From: Rossi, Steph @ Sydney <Steph.Rossi@cbre.com>
Sent: Thursday, 27 January 2022 10:58 AM
To: Alejandra Rojas <Alejandra.Rojas1@det.nsw.edu.au>
Cc: Spedding, Stephen @ Sydney <stephen.spedding@cbre.com.au>; Carmody, Greg @ Sydney <Greg.Carmody@cbre.com>; Jack Bruderlin (Jack Bruderlin) <Jack.Bruderlin@det.nsw.edu.au>; Lawler, Nicholas @ Sydney <Nicholas.Lawler@cbre.com>; Chris McGillick <CMcGillick@ethosurban.com>; Ella Coleman <EColeman@ethosurban.com>
Subject: RE: RFI - DPIE further comments

1. *The Department previously requested details of internal layout of Childcare Centre and internal play spaces. This information has not been provided. Please submit amended plans with the internal layout with test fit concept plan to demonstrate compliance with the required play area for 40 preschool children.*

NEW LIVERPOOL PRIMARY SCHOOL

Drawing Title
WALL SECTIONS - BLOCK Y SHEET
1

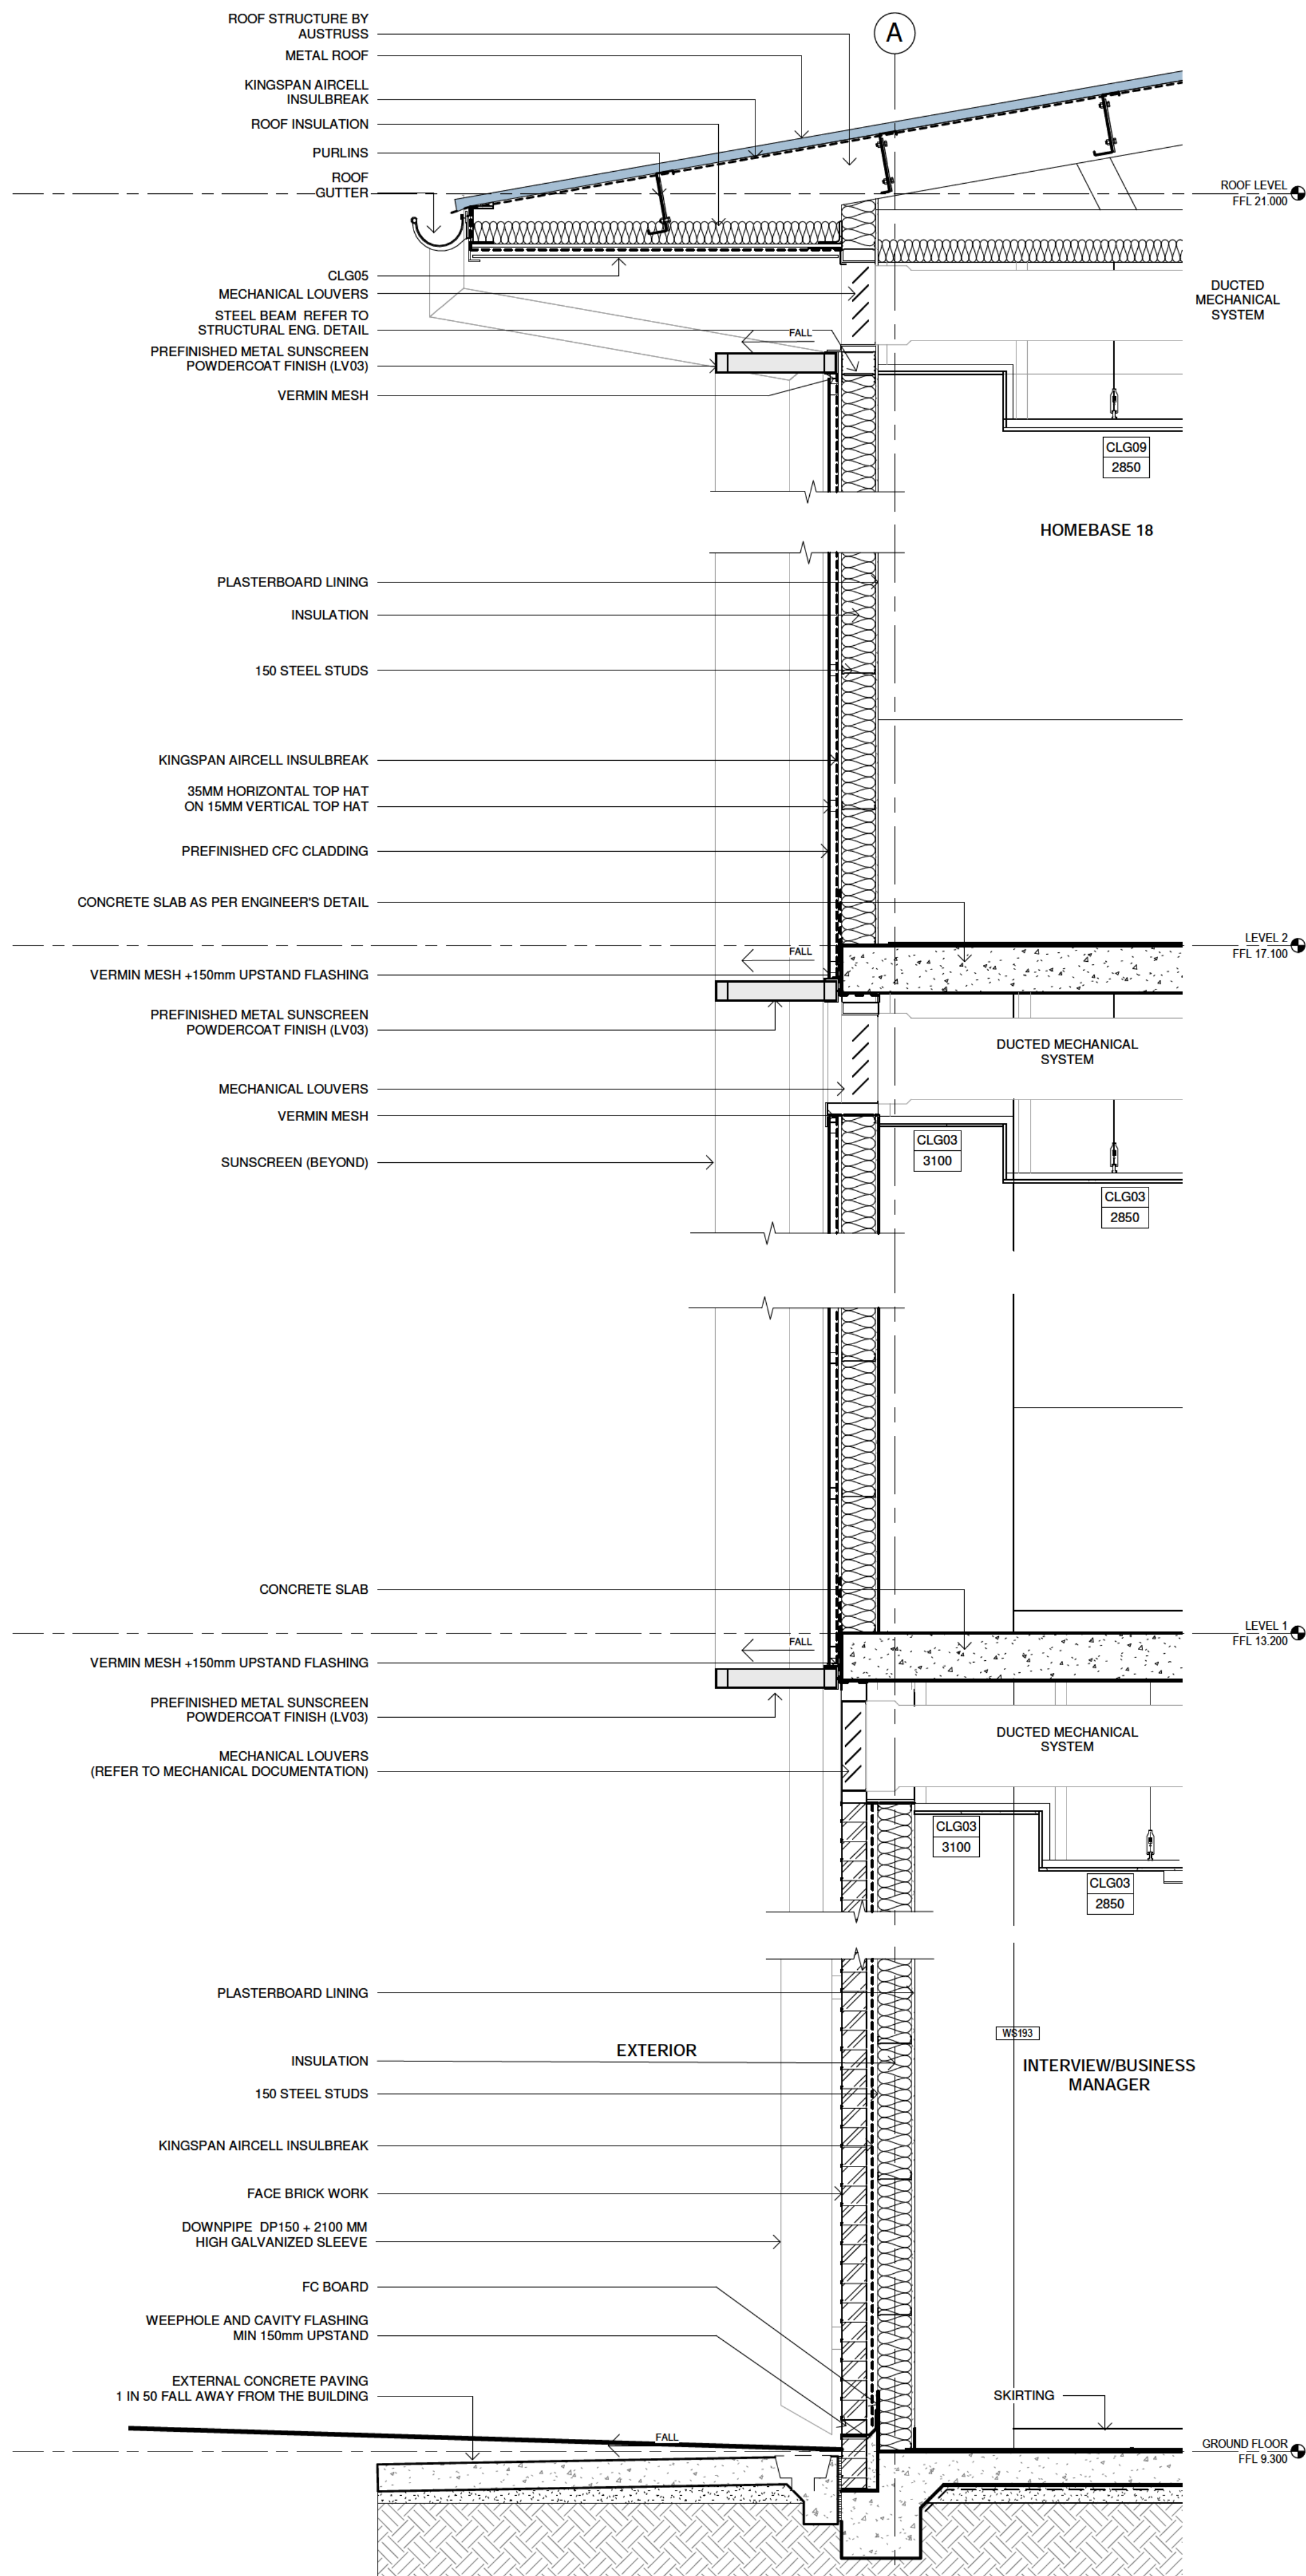
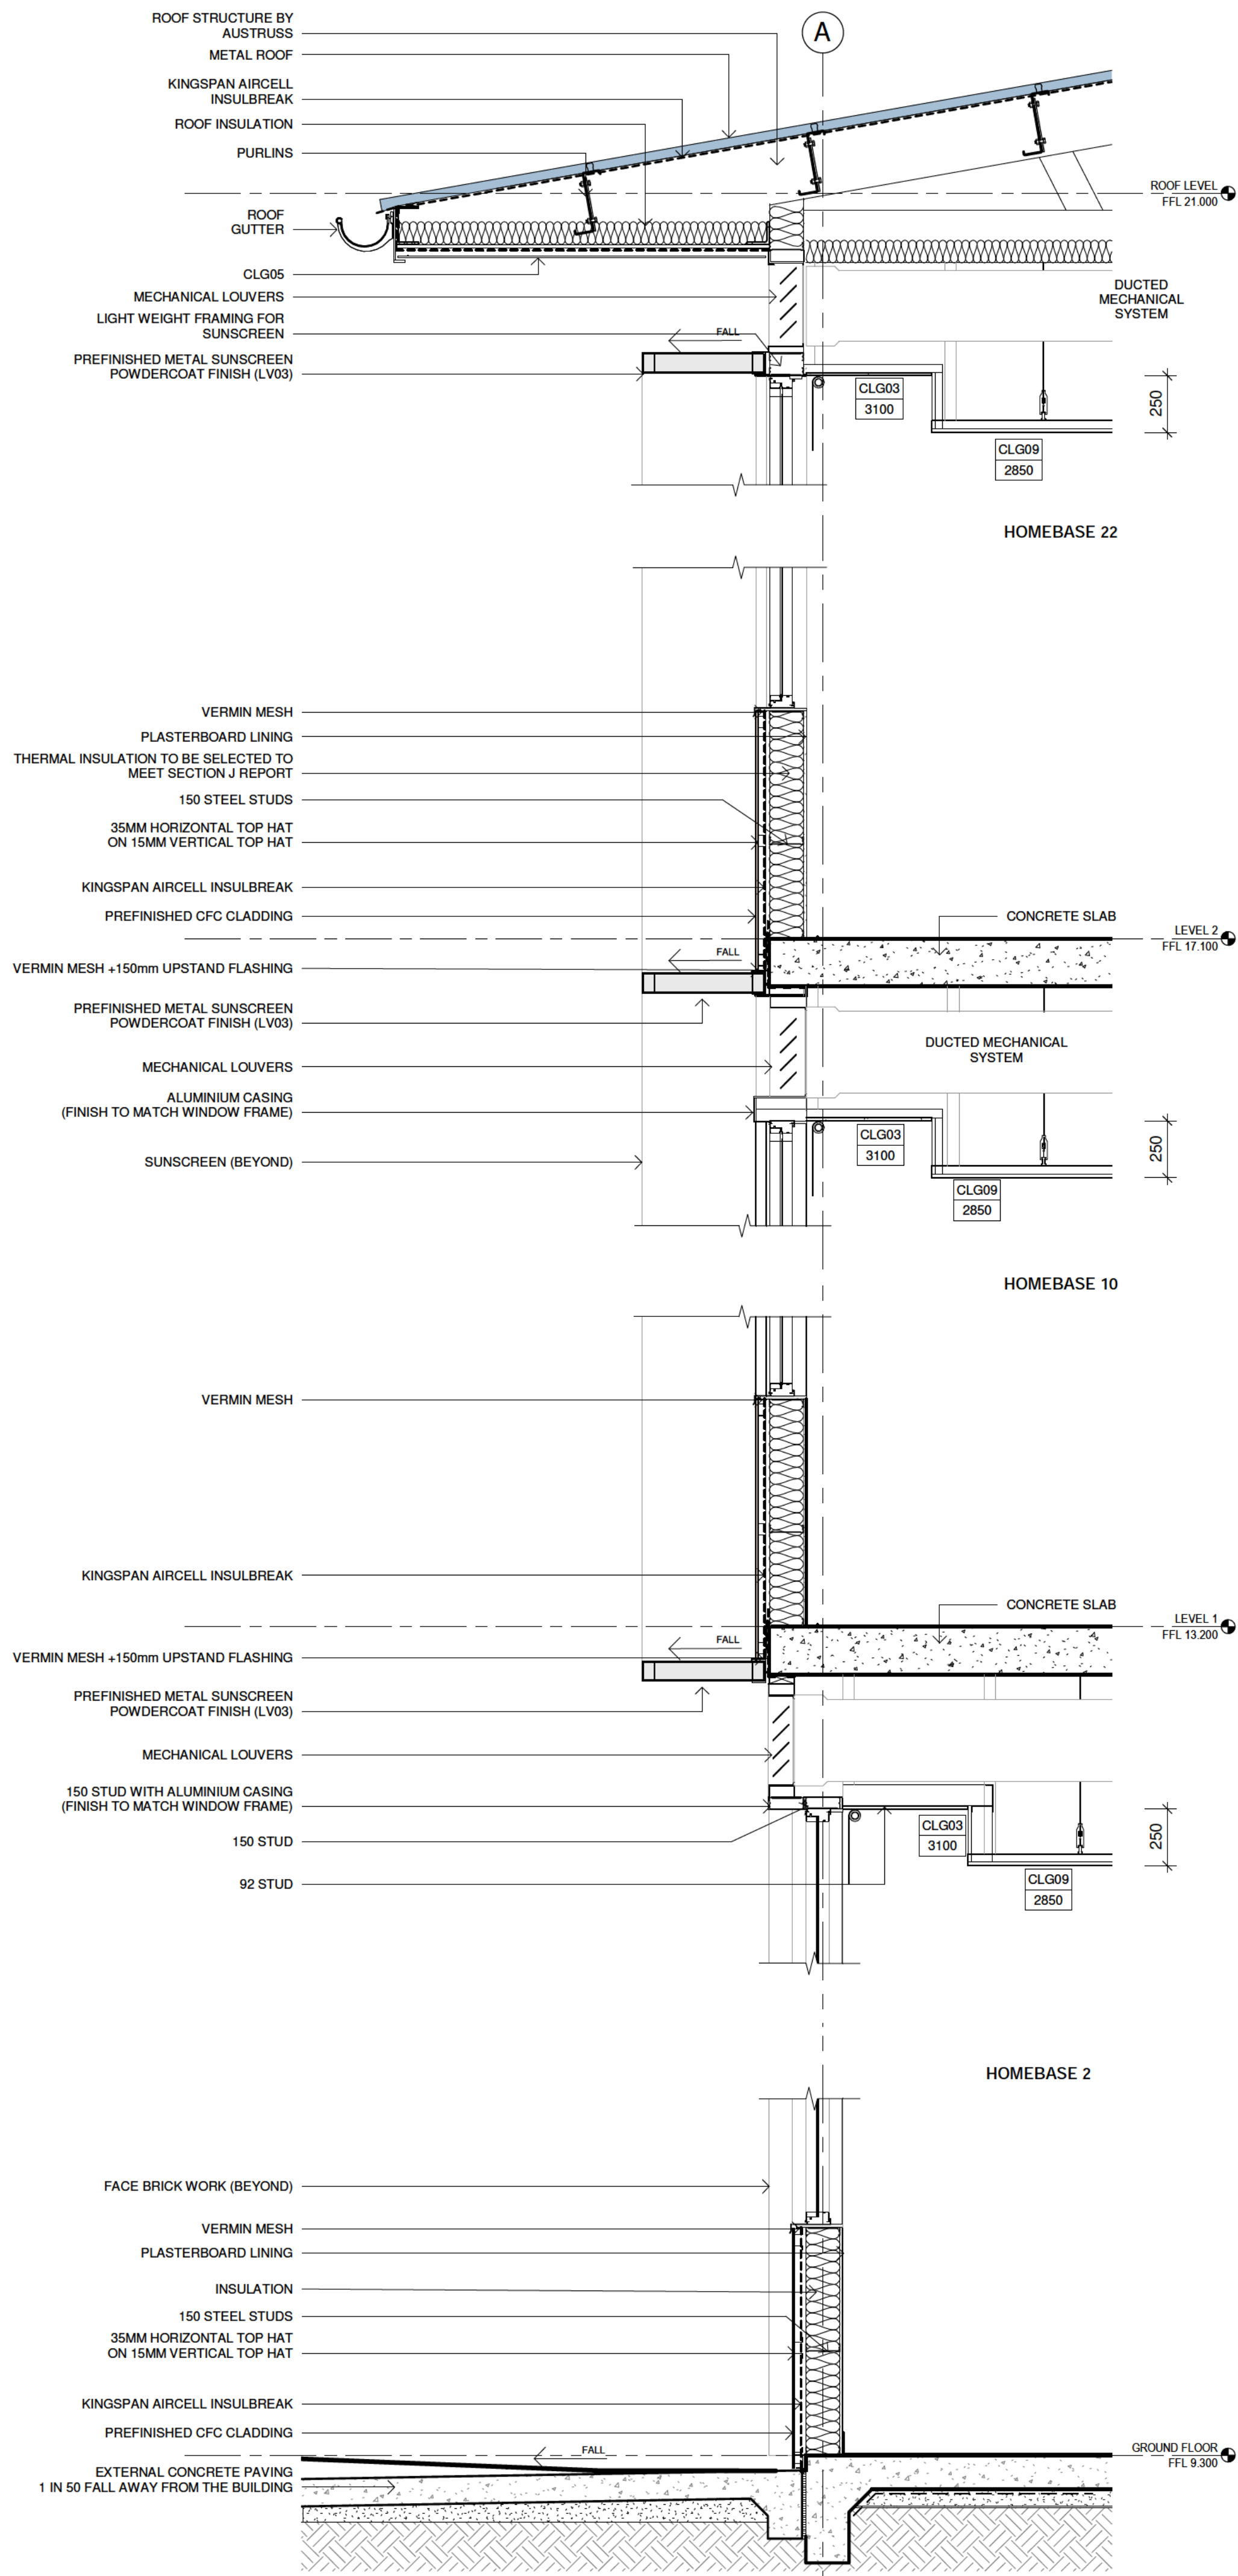
- *the western façade should have additional external sun shading and drawings should be amended to include this feature. The submitted documents does not show locations and sizes of shading devices. Amended*

architectural drawings do not demonstrate that any shading devices have been added.

The building facades have been designed based on input from the ESD engineer (refer statement from Steensen Varming at **ATTACHMENT F**) to balance the priorities for daylight, solar ingress, thermal performance, natural ventilation, and glare control among other competing factors. Refer drawing at **ATTACHMENT G** for detailed sections showing extent of shading proposed.
